## PRODUCT BULLETIN JSK 37U"W" Topplate Liner Update

## **Effective October 2009**

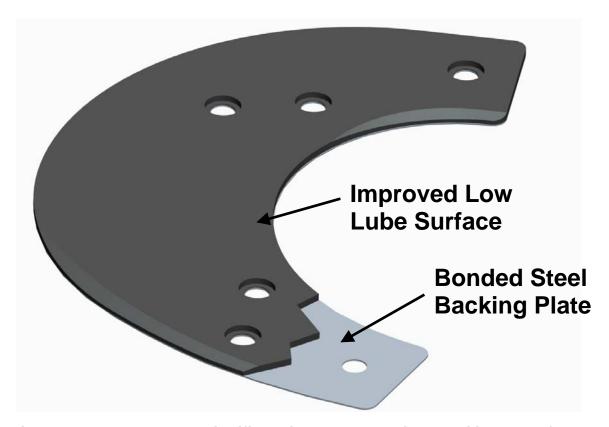
Jost International announces the availability of an improved low lube liner.

The new liner is reinforced with a bonded steel backing plate.

- > Field tests have revealed significant improvements in durability under frequent coupling conditions.
- > This product improvement will be a running change

> After October 1<sup>st</sup> <u>ALL</u> Low Lube Fifth Wheels <u>WILL BE</u> supplied with the new Reinforced Low Lube Liners.
